SERIAL: NLS-93-004
10 CFR 50.90
TSC 92TSB11

BRUNSWICK STEAM ELECTRIC PLANT, UNIT NOS. 1 AND 2
DOCKET NOS. 50-325 & 50-324/LICENSE NOS. DPR-71 & DPR-62
REQUEST FOR LICENSE AMENDMENT
CONTROL BUILDING EMERGENCY VENTILATION SYSTEM
(NRC TAC NOS. M85143 AND M85144)

BASIS FOR CHANGE REQUEST

FIGURE 1
 CONTROL BUILDING EMERGENCY
 VENTILATION SYSTEM
 CHLORINE DETECTION/ISOLATION LOGIC
 EXISTING CONFIGURATION

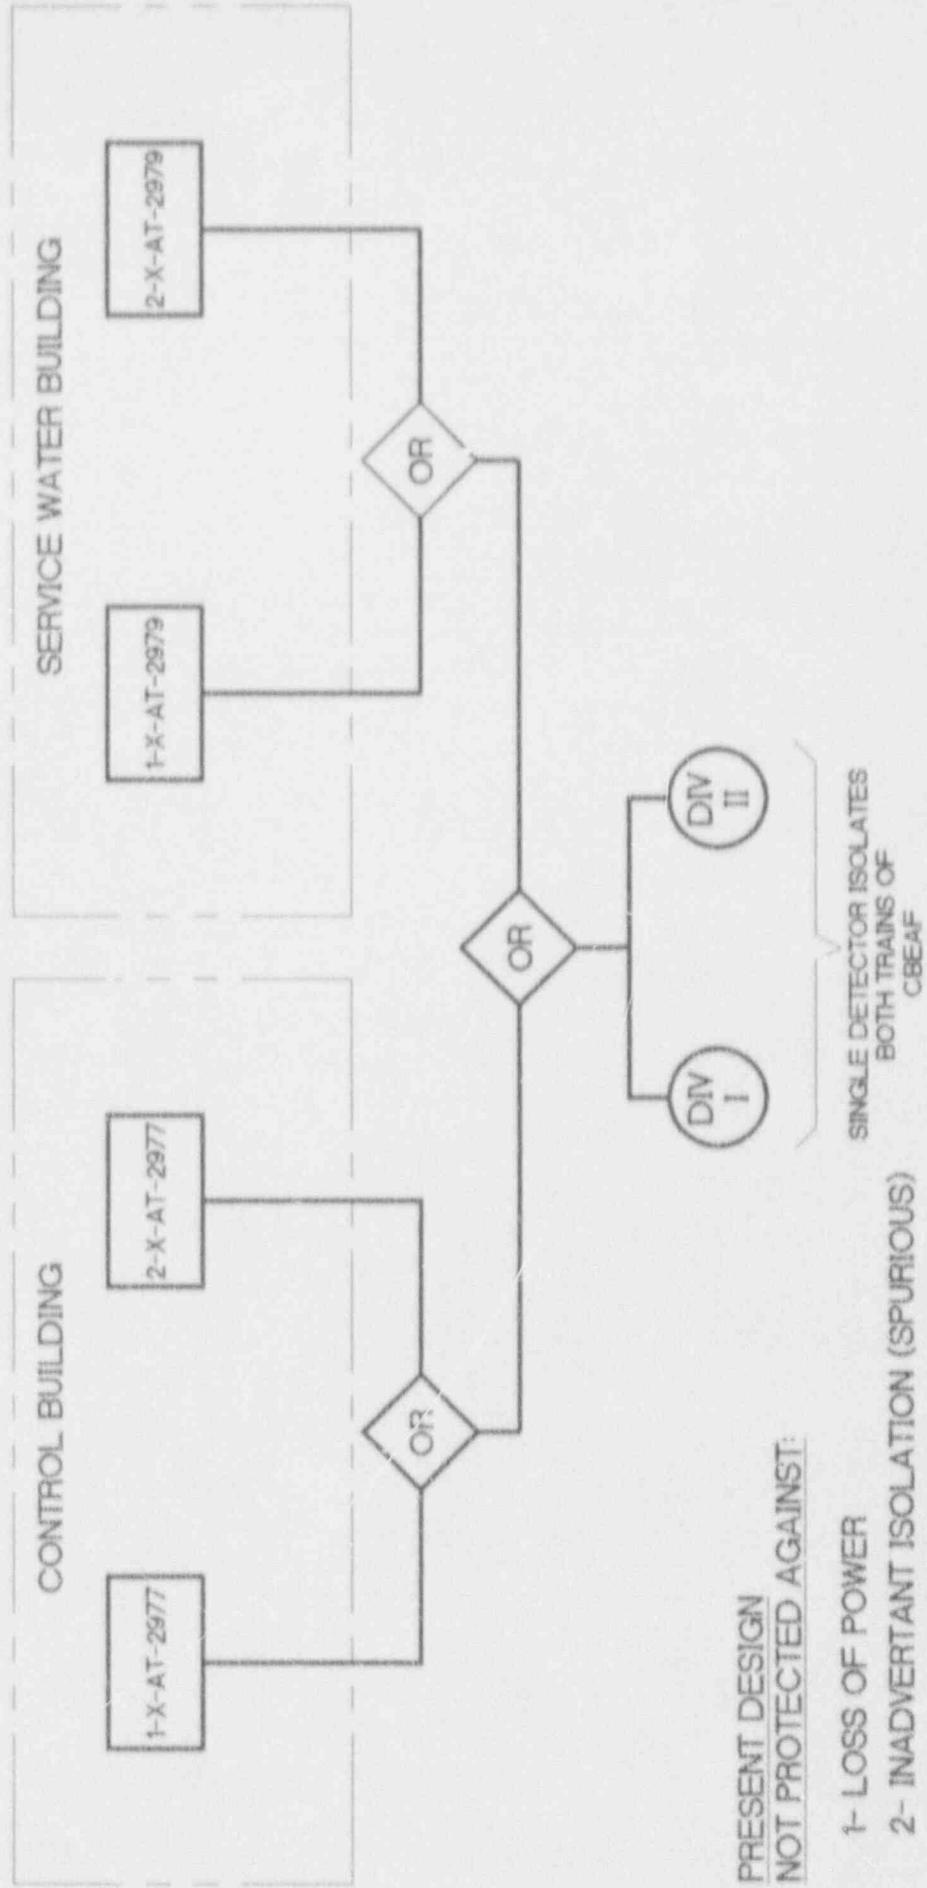
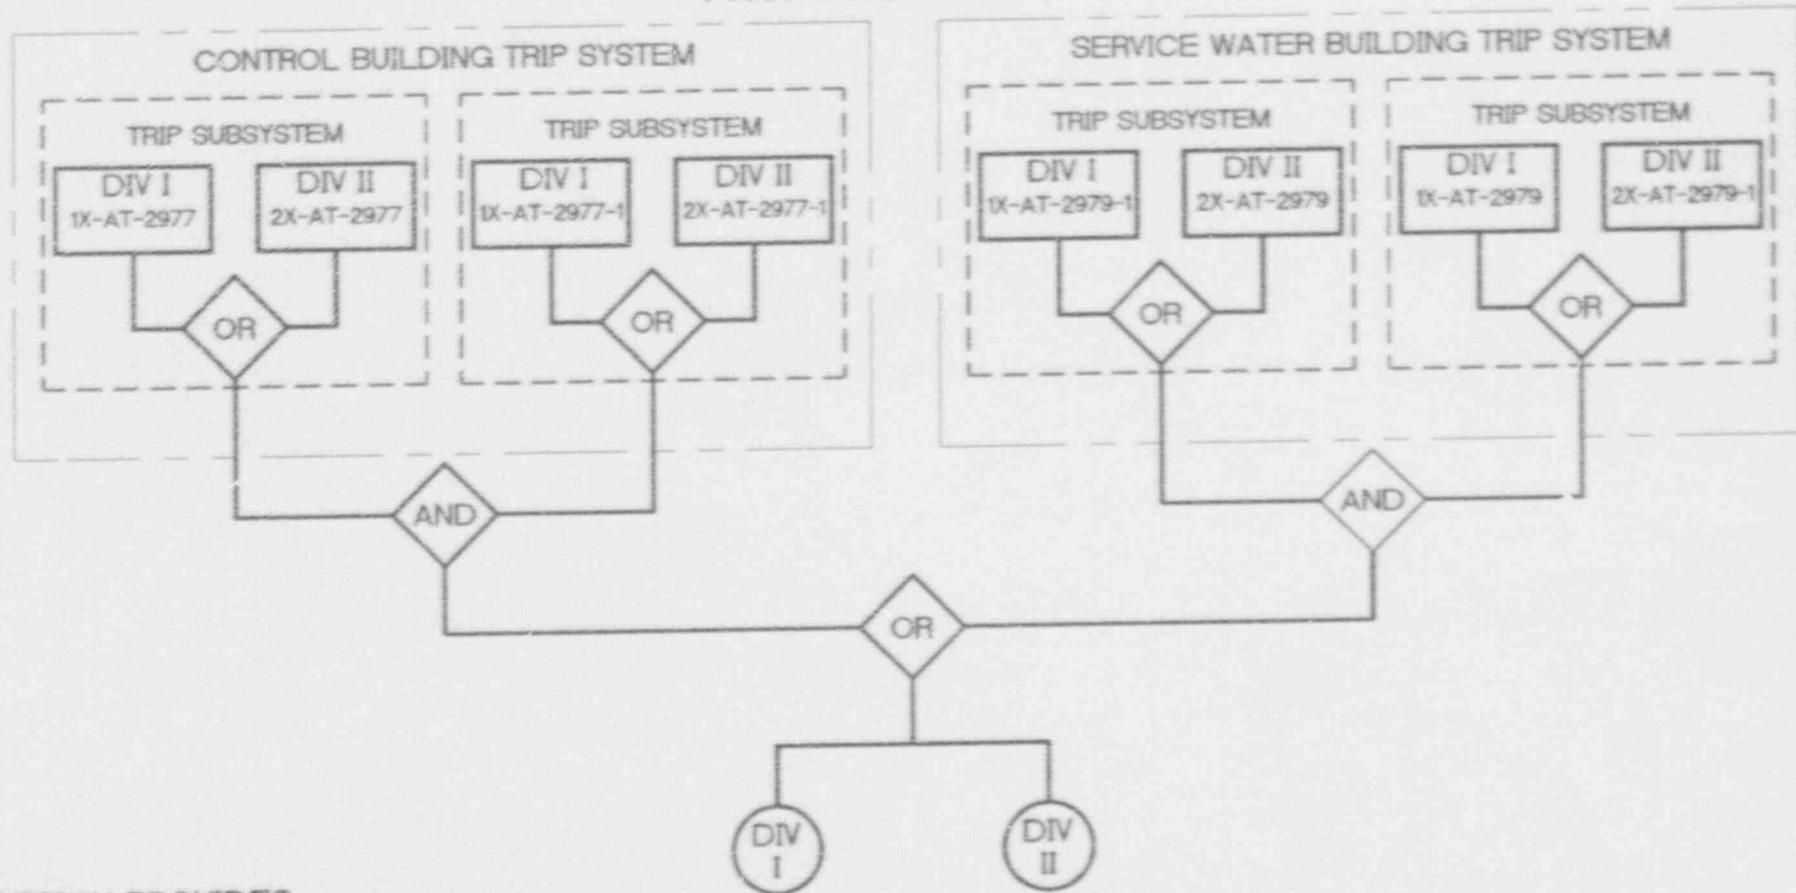
The Brunswick Plant is implementing a plant modification (PM 92-108) to eliminate the single failures described above. The permanent resolution of the chlorine detection logic single failure input to the CBEVS is to provide a logic design which would not allow a single credible failure to disable the protective function of the CBEVS. In order to provide this design, a one-out-of-two-taken-twice logic is being utilized (Reference Figure 2). This design requires the addition of two (2) detectors per sampling location, forming two trip subsystems within each trip system (one trip system at the Control Building intake air plenum and one at the Service Water Intake Building near the chlorine tank car). The number of detectors utilized at each location increases from the present design of two to a total of four. The total number of detectors associated with the chlorine detection logic input to the CBEVS increases to eight.

The four detectors per sampling location (trip system) are being installed divisionalized such that two detectors are in Division I and two in Division II. The logic is designed such that two detectors (one per trip subsystem) at either location (trip system) will be required to sense chlorine in order to affect an isolation of the CBEVS. This design ensures that spurious detector isolations do not isolate the CBEVS, causing unnecessary operator actions, while still providing adequate chlorine gas protection by virtue of redundant detection systems. In addition, use of the one-out-of-two-taken-twice logic ensures that a loss of one division of power to the detectors will not place the

The current configuration of the chlorine detection logic is shown in Figure 1. Each trip system consists of 2 detectors, with a one-out-of-two logic design. The detection system is not a single-failure proof design; however, each detector fails in a safe design configuration, resulting in isolation of the CBEVS. The current Technical Specifications reflect this design, with a 7-day ACTION statement for one chlorine detector of either or both trip systems being inoperable (loss of redundancy), and a requirement for isolation of the Control Room envelope within one hour with both detectors of either trip system inoperable (loss of function).

As stated previously, the current chlorine detection/isolation configuration consists of two trip systems; one located at the intake of the CBHVAC System, and the other located near the chlorine tank car. Figures 1 and 2 provide simplified sketches of the current and modified chlorine detection and isolation logic for each trip system. The current instrumentation specification identifies actions necessary if one or both detectors of either trip system becomes inoperable (seven day LCO and one hour LCO ACTION statements).

FIGURE 2
 CONTROL BUILDING EMERGENCY
 VENTILATION SYSTEM
 CHLORINE DETECTION/ISOLATION LOGIC
 PROPOSED CHANGE
